# Certificate of Appropriateness

2007 E Windsor Pl

North Point South Historic District

Exterior renovation of property per attached drawings (five pages). Roof to be Landmark Pro Moire Black.

1 PROPOSED PLAN  
SCALE: 1/4" = 1'-0"

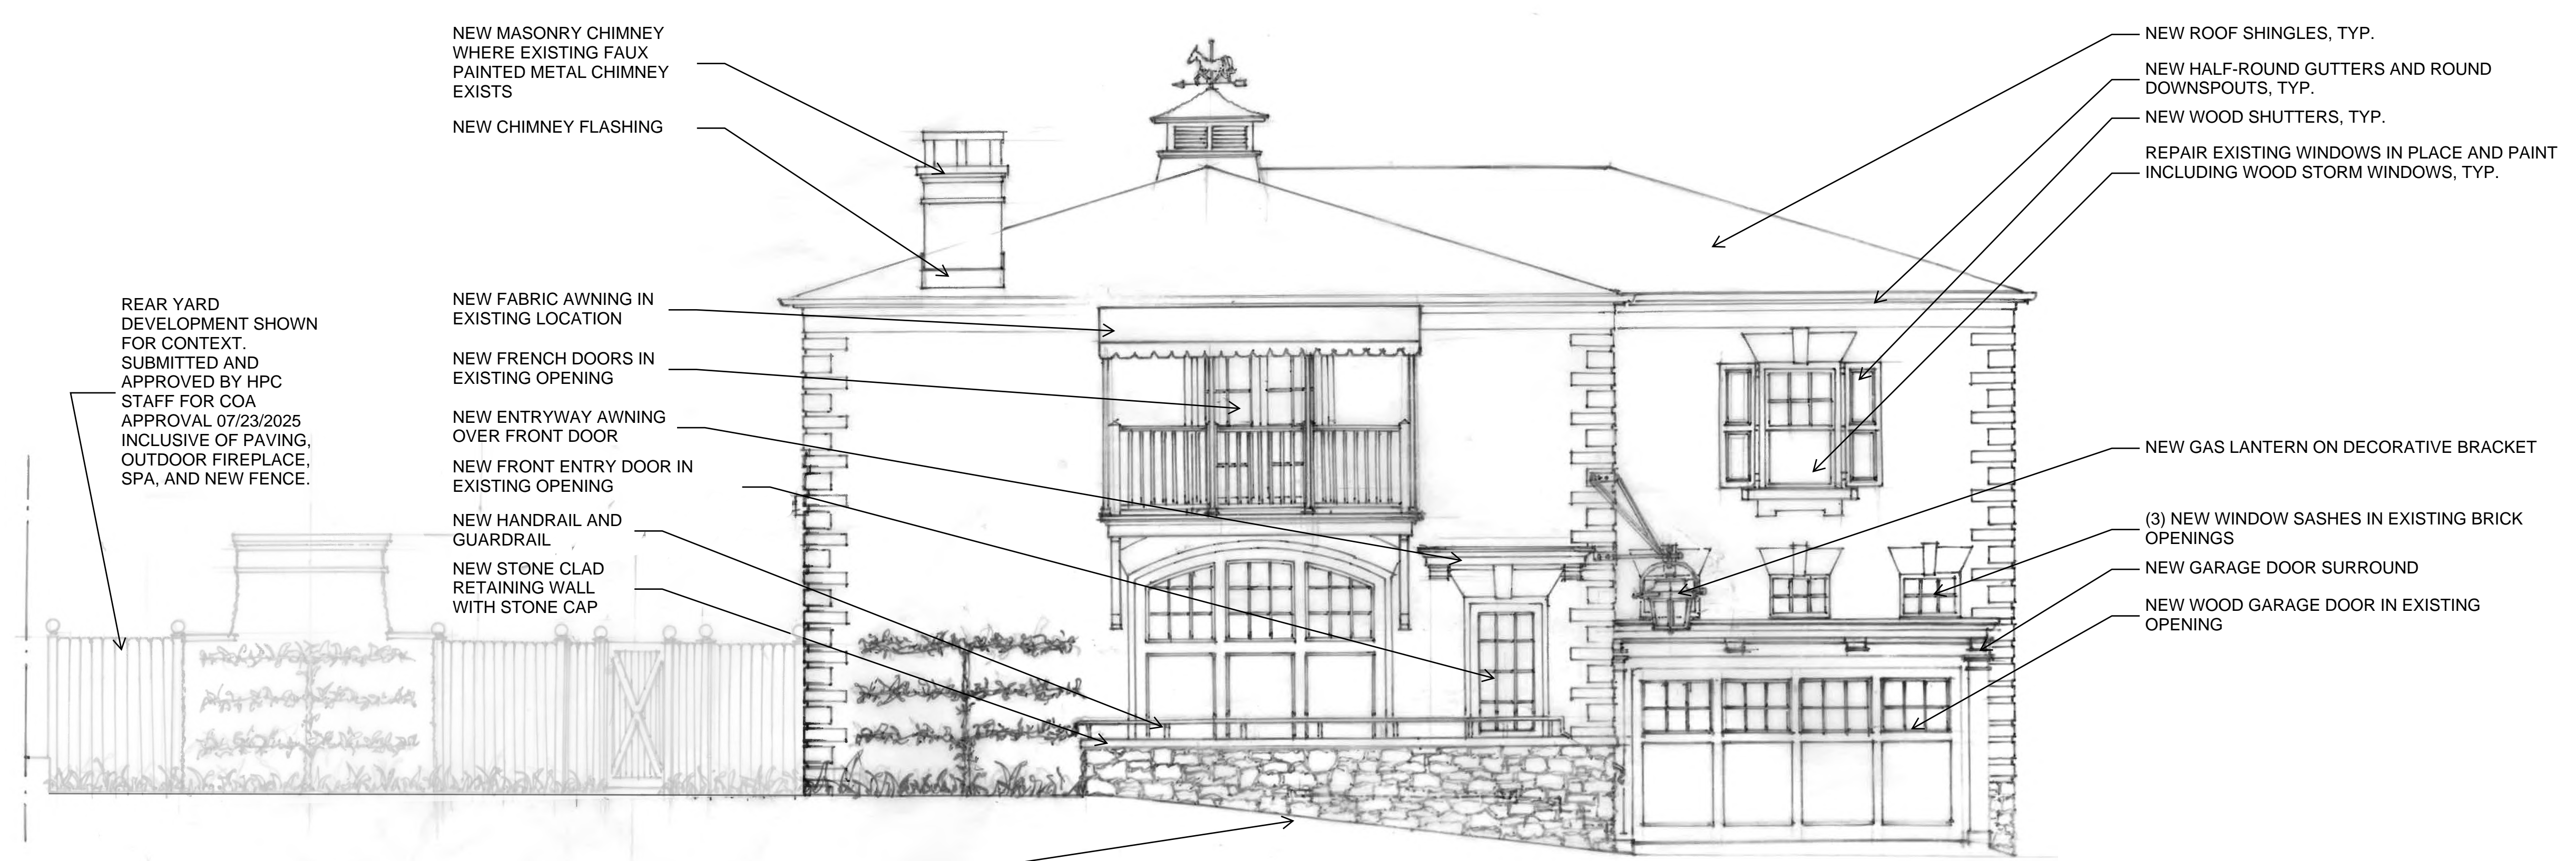
**Awning must be made a knit or woven product. Plastic sheeting is not permitted. New chimney must be installed using step-flashing.**
